# PlanGrid Task Report - Feb 14, 2024

**L04916\_Princeton Woods FSU (Dumfries, VA)**

**#123 [CNTL 098] Ansul pull labeling.**

M-301

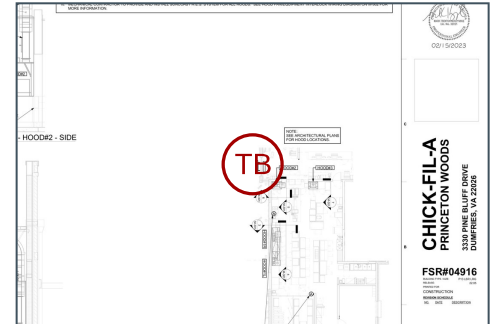
Label all Ansul pull stations  
for which hoods they serve.

M-301

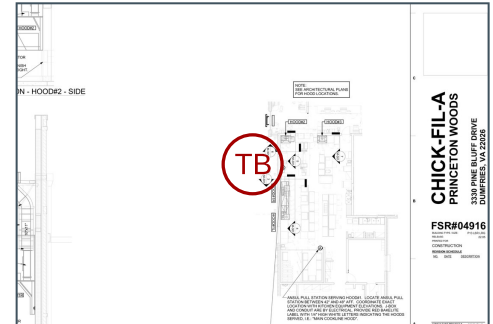
**#122 [CNTL 107] (MISC) Missing Ansul pull stations**

Ansul pull stations are not yet installed at locations designated

M-250

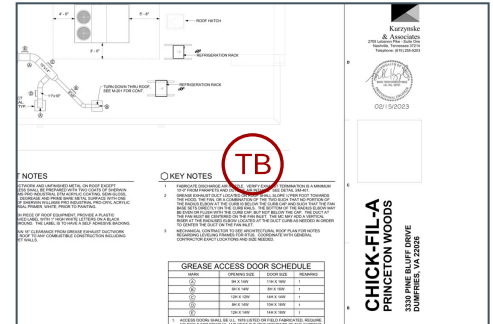
**#118 [UNIT 168] Equipment not secured properly.**

Equipment not secured properly to curb, high wind/ seismic clips not installed. Mechanical stated that unit package did not come with seismic clips.
